BID ADDENDUM NO. 5

PROJECT NAME: PORT CHESTER HIGH SCHOOL ADDITIONS, ALTERATIONS
AND ATHLETIC FIELD

F&D PROJECT #: PCHS # 17295.03

DATE: February 28, 2019

DRAWING TITLE:
PART FIRST & SECOND FLOOR PLANS

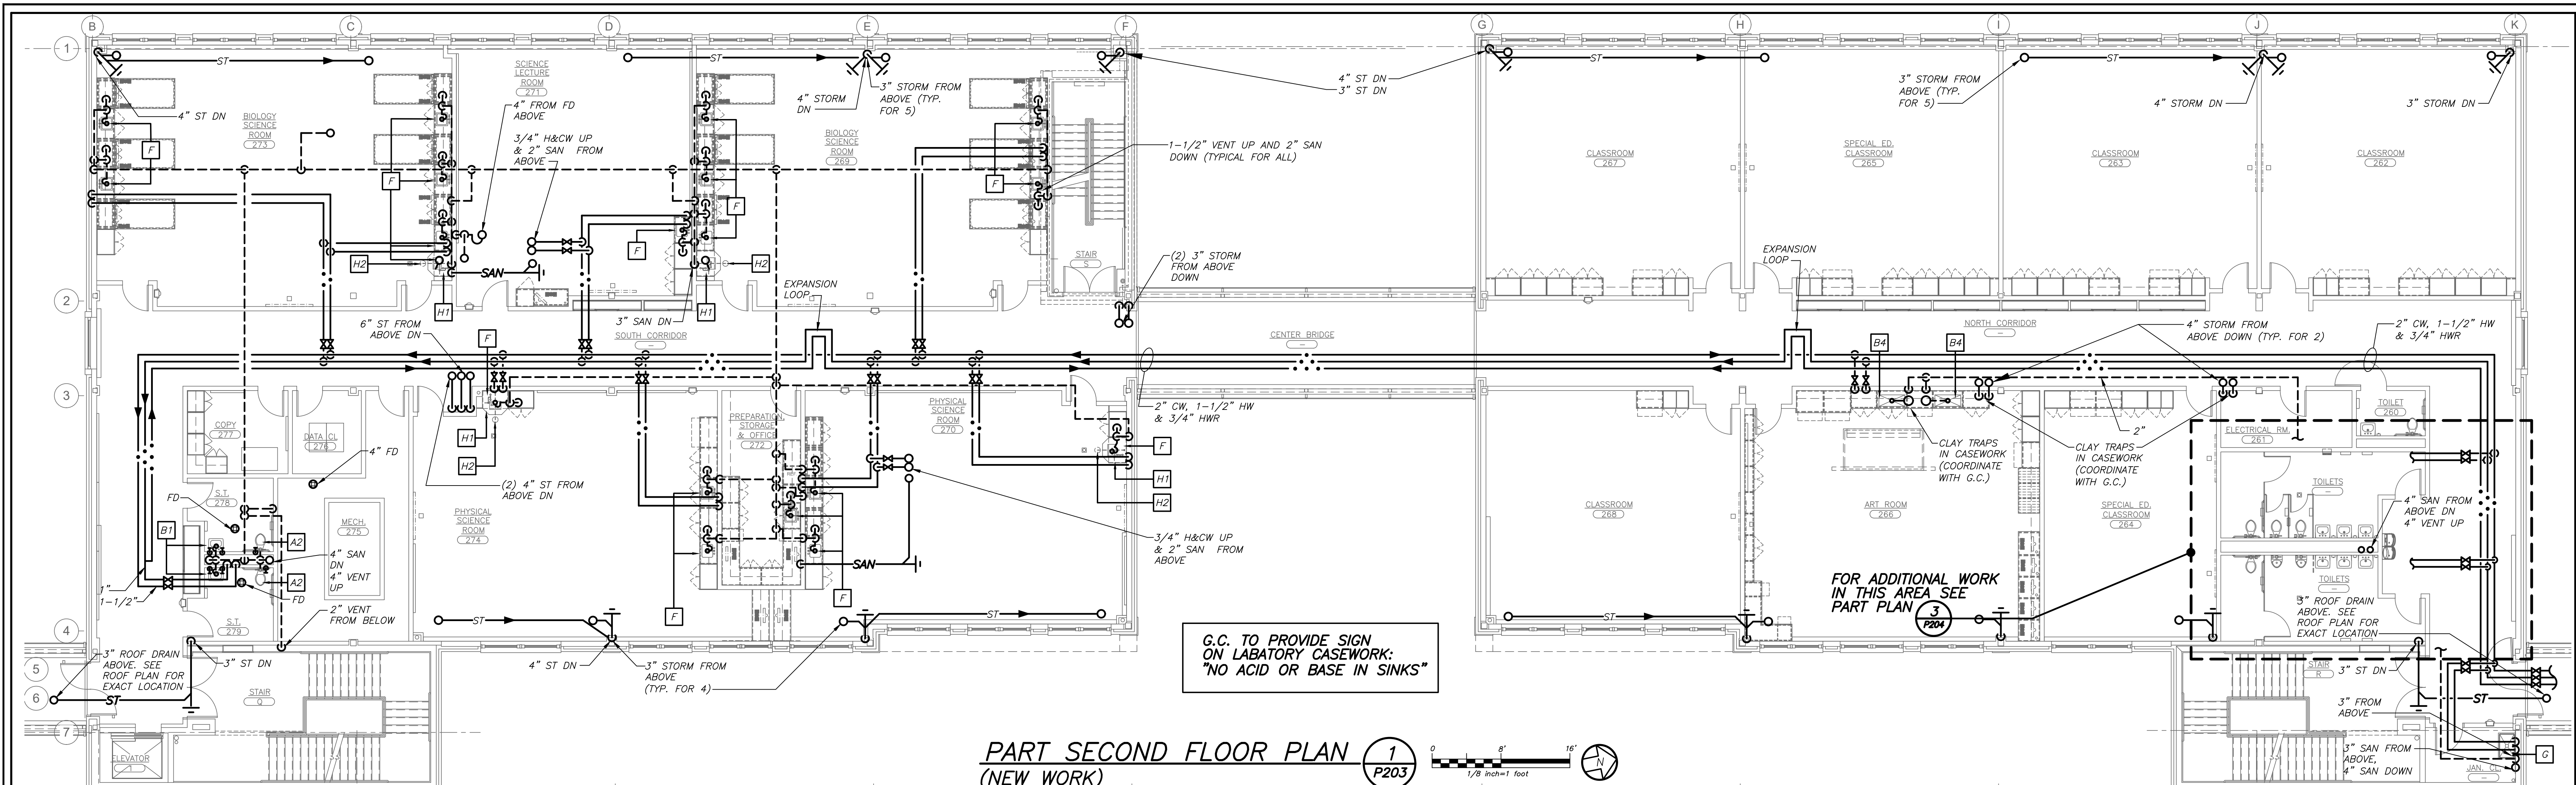
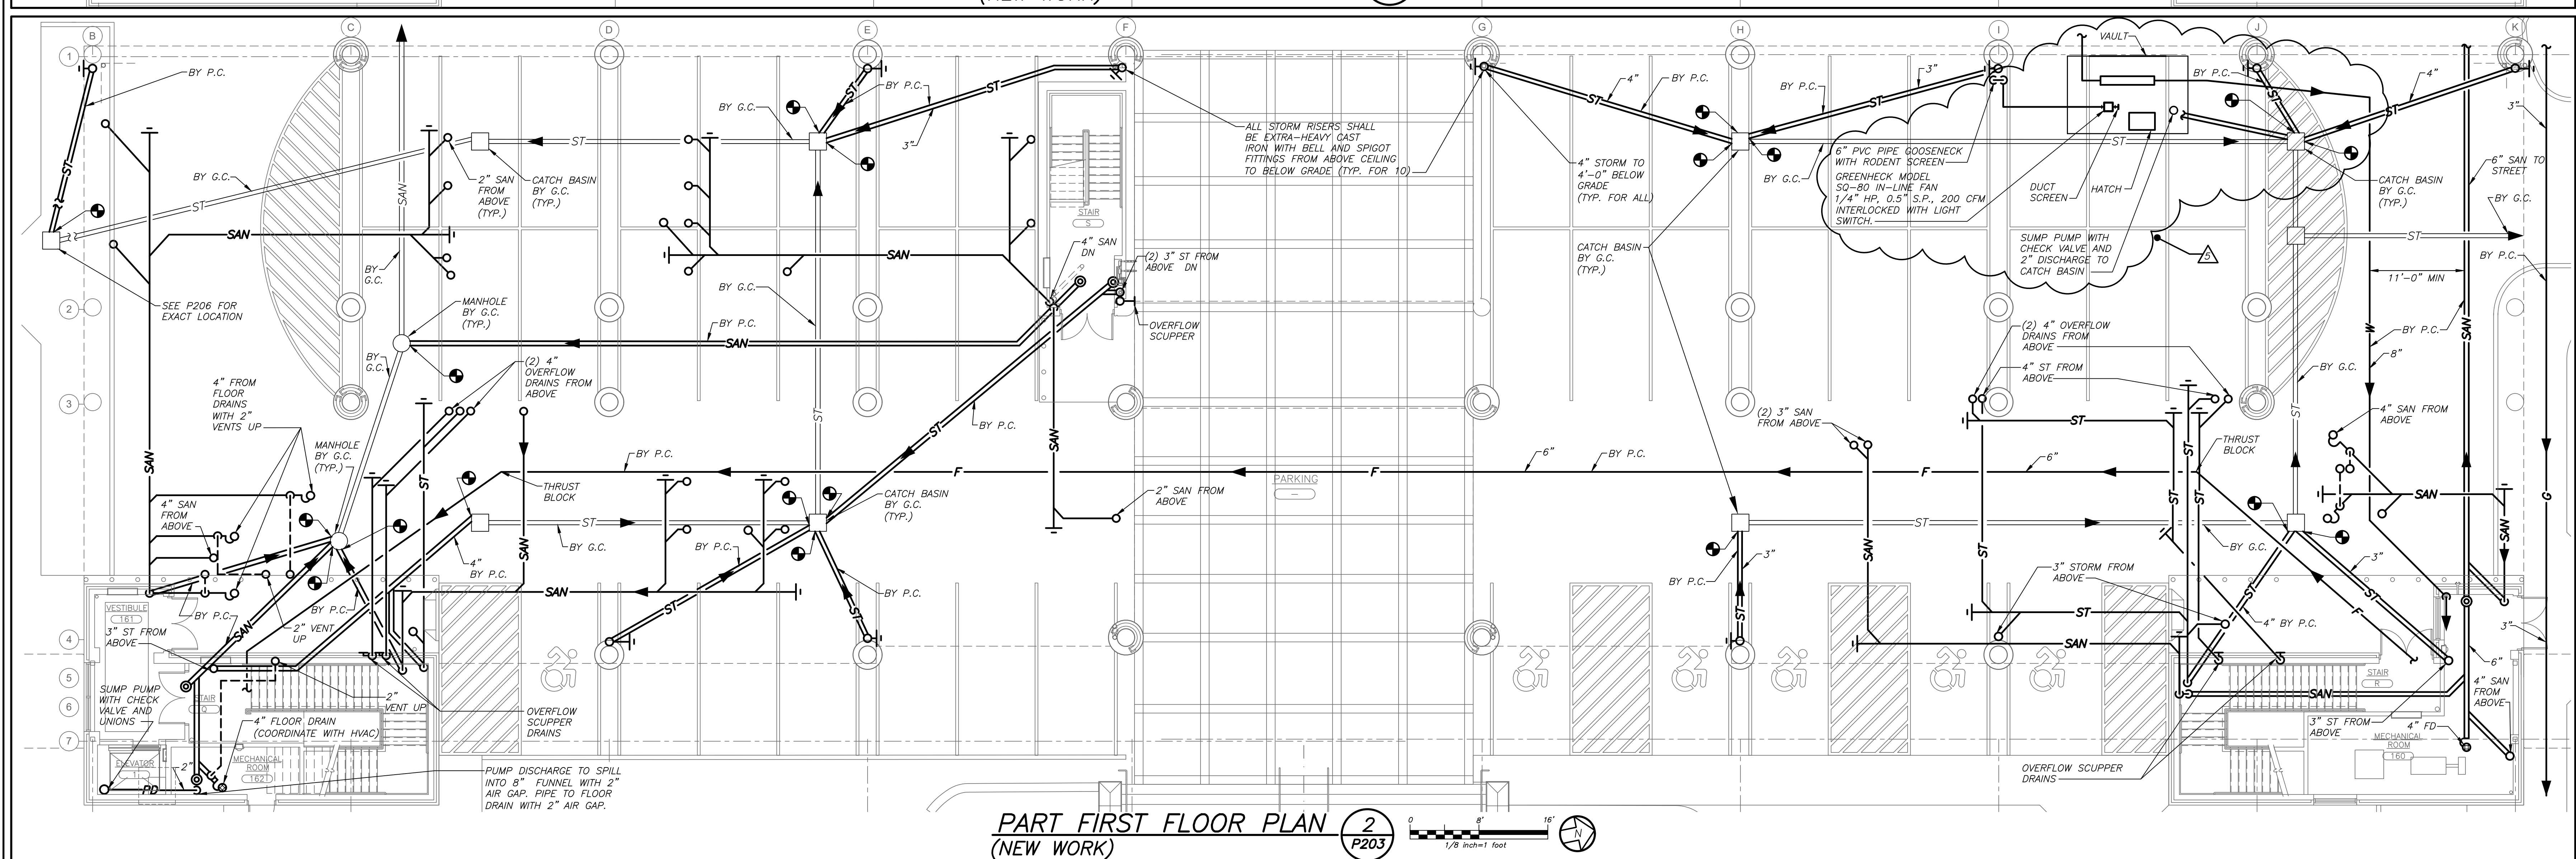
Add: A new 14'L x 8'W x 8'H precast concrete vault has been added to the project. See requirements listed below:

- See revised P203 and P206 for exact location and additional information.
